THE CITY OF SAN DIEGO

July 25, 2007

Subject: Total Maximum Daily Loads for Indicator Bacteria, Project 1 – Beaches and Creeks
in the San Diego Region

32nd Street Canyon Treatment/Infiltration Above Outfalls

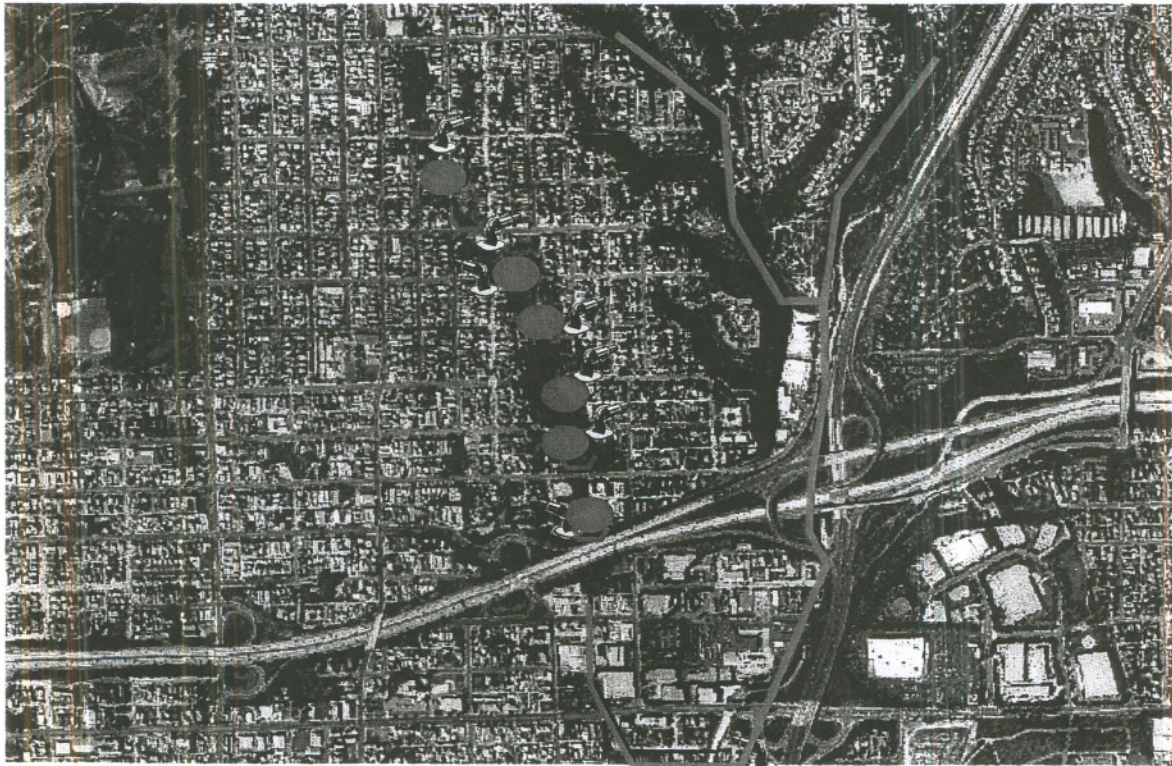
Attached is a series of graphics which represent specific scenarios for Regional Board staff to determine, on a case by case basis, whether infiltration below storm drain outfalls would lead to compliance. When evaluating these graphics, please make the assumption that 1) these facilities could be permitted, 2) they are designed with adequate capacity, 3) they function properly, and 4) they reduce pollutant loading to the levels required by the TMDL. The graphics show specific storm drain outfall and propose infiltration facility sites in the 32nd Street Canyon in the City of San Diego. Would either the "Mouth of Canyon" or "Base of Canyon Wall" option result in compliance with the TMDL given that both options would result in using receiving waters to convey waste between the outfall and the infiltration facility? We encourage Regional Board staff to visit this site in the field prior to responding to this question and would be happy to facilitate a site visit if requested.

32nd Street Canyon Canyon Mouth Option Detail

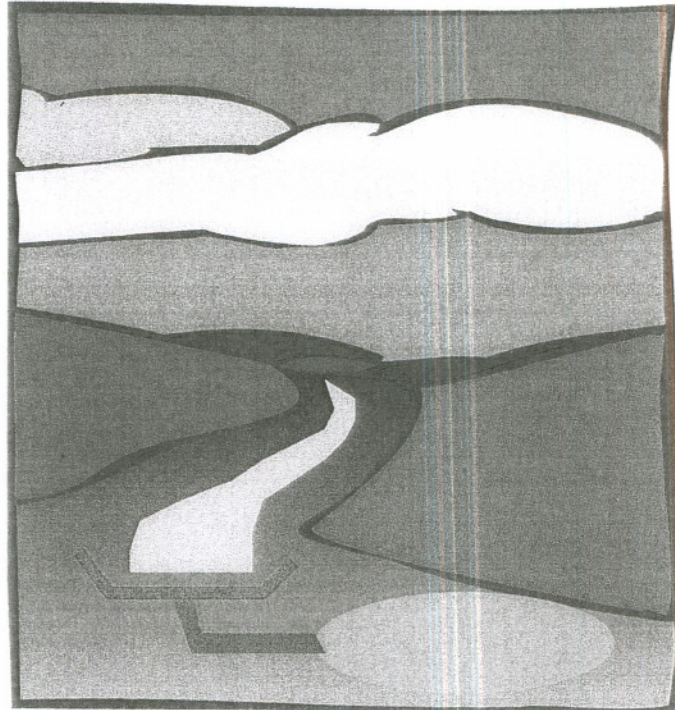
- In this example, runoff is captured by a headwall and piped to a subsurface infiltration pit.
- The gold area represents the footprint of the pit; located to avoid impacts to receiving waters and sewer lines.
- Water upstream of the headwall may not meet the WLAs

Base of Canyon Wall Option Detail

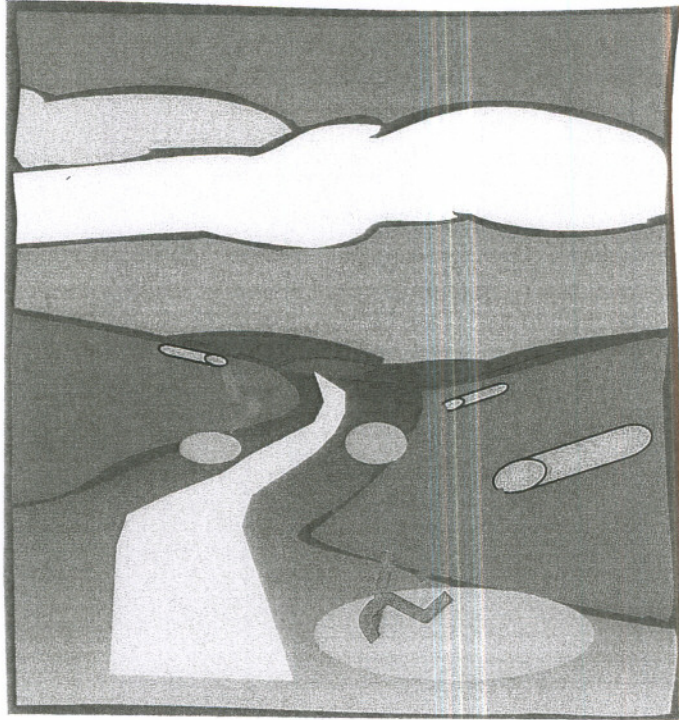
- In this example, runoff is intercepted at the base of the canyon wall, below the storm drain outfall but before it reaches the main channel in the canyon.
- Water upstream of the headwall may not meet the WLAs.
